***Building Envelope Case Study :  
from Initial Constructability Review Through  
Occupancy 2016-2017***

# Jenkins & Nanovic Halls – Notre Dame

INITIAL  
QUALITY-  
REVIEW OF  
CONTRACT  
DOCUMENTS IN  
DD STAGE

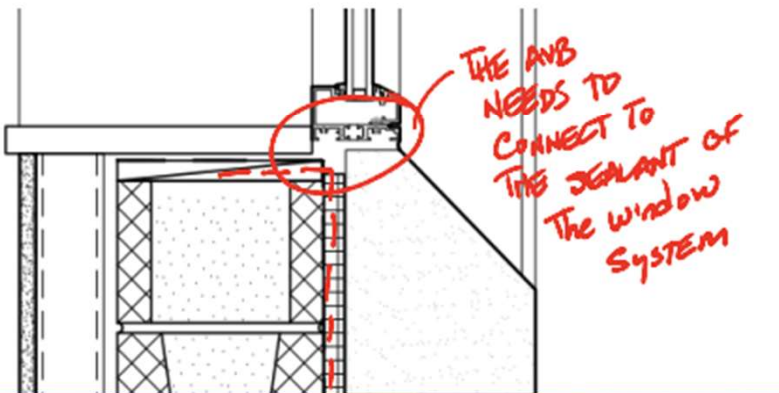
26	Detail 4/A5.10
	<ol style="list-style-type: none"> <li>There needs to be an AVB attachment to the window sealant. I suggest ETA.</li> <li>There should be sheathing on the metal framing.</li> <li>The AVB needs to be extended.</li> </ol>

27	Detail 4/A5.10
	<ol style="list-style-type: none"> <li>There needs to be an AVB attachment to the window sealant. I suggest ETA.</li> <li>AVB needs to be extended.</li> </ol>

29 Detail 1/A5.51

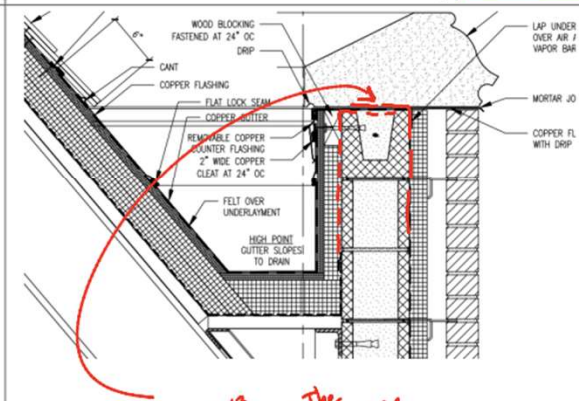
- The roof AVB should go up the parapet and over...and the wall AVB should go up the wall and over the roof AVB.

31 Detail 1/A5.55

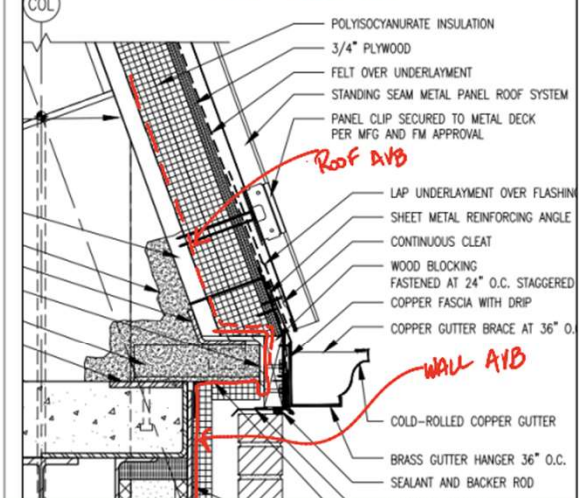
- The roof AVB should go down and on top of the wall AVB...and the wall AVB should go up the wall.

**Detail 13/A5.51**

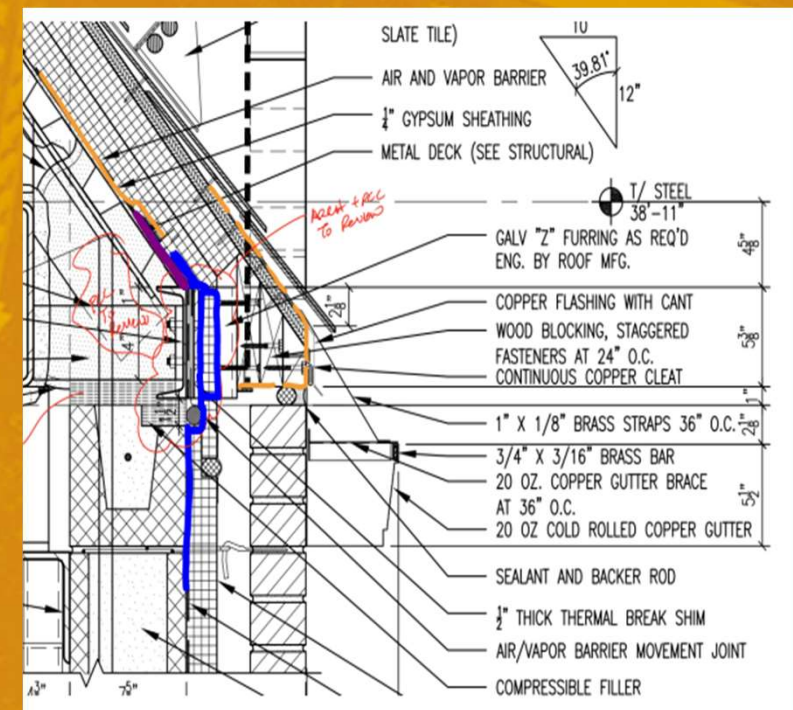
THE USE OF THIS EXP JOINT DETAIL IS CONTINGENT UPON THE QUALITY OF INSTALLATION. IF THE INTEGRITY OF THE AVB CANNOT BE MAINTAINED THEN THE USE OF AN EXTRUDED SILICONE ETA IS TO BE USED.

PROVIDE MOCKUP FOR REVIEW BY ARCHITECT

for constructability & VB location and issue a revised sketch. We need to VB is not in between steel elements and still make a connection. eral wool will need to be installed prior to the SPF.

Installed detail as  
designed

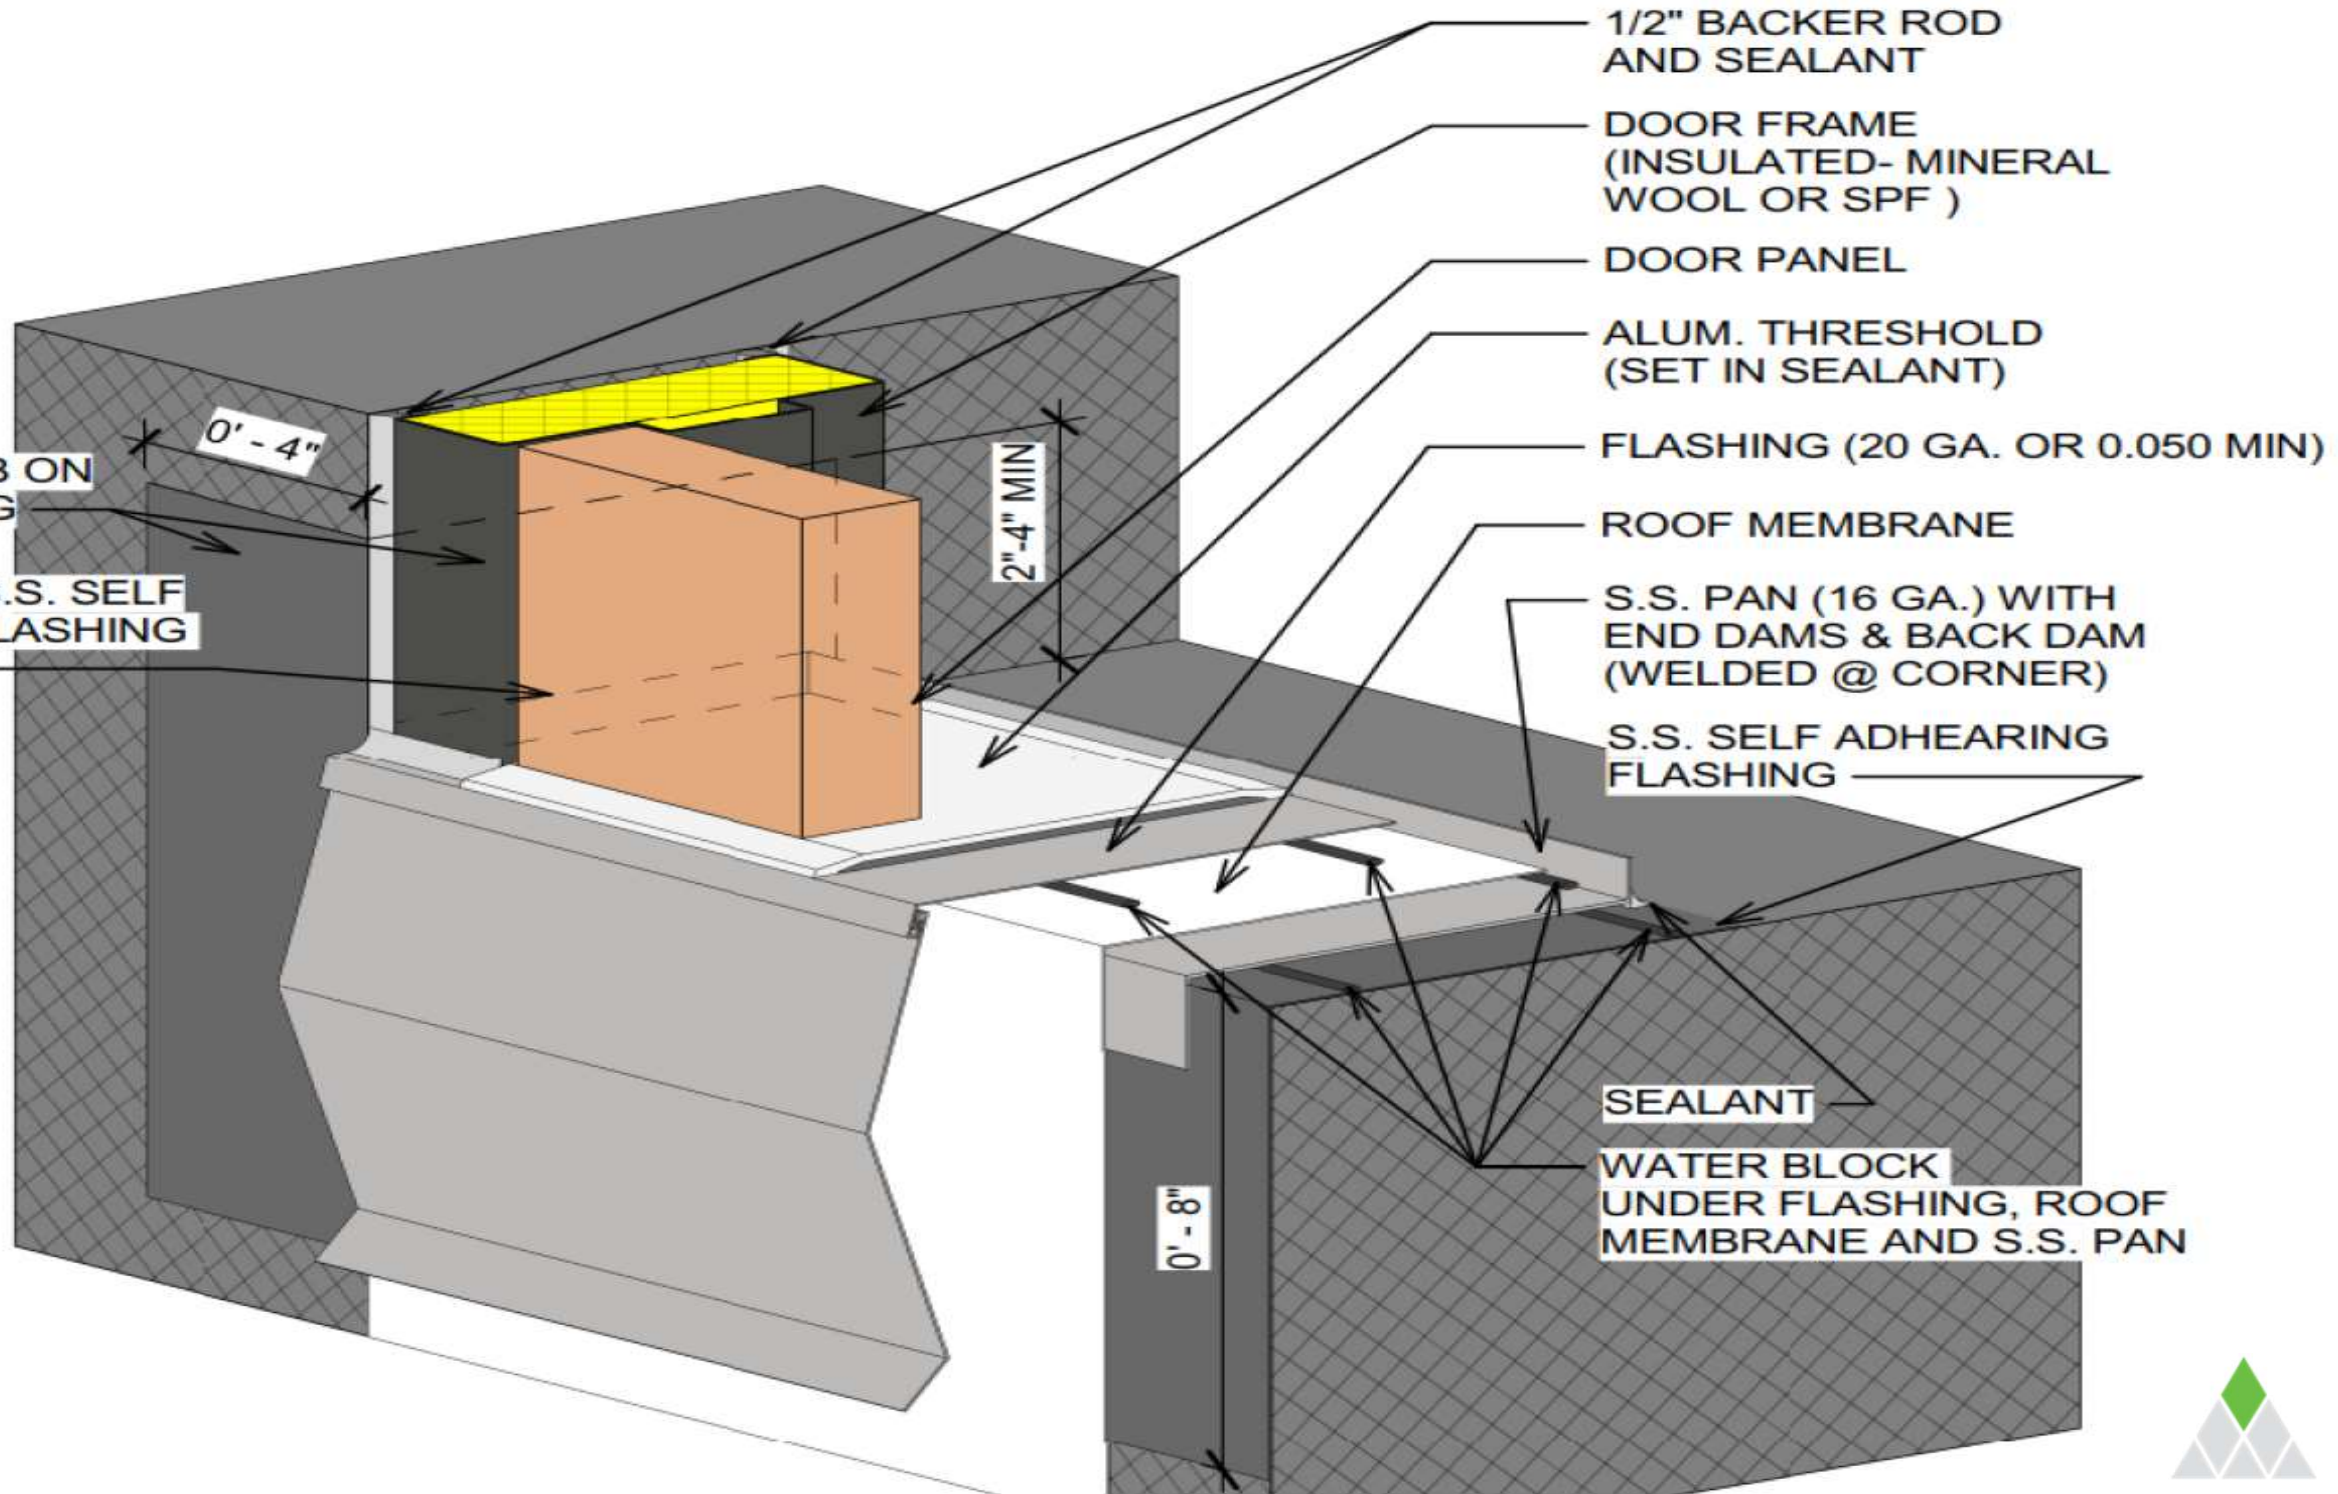
**The roof deck flutes under the curb should be filled with SPF (closed cell) in order to prevent air from getting under the roofing system**
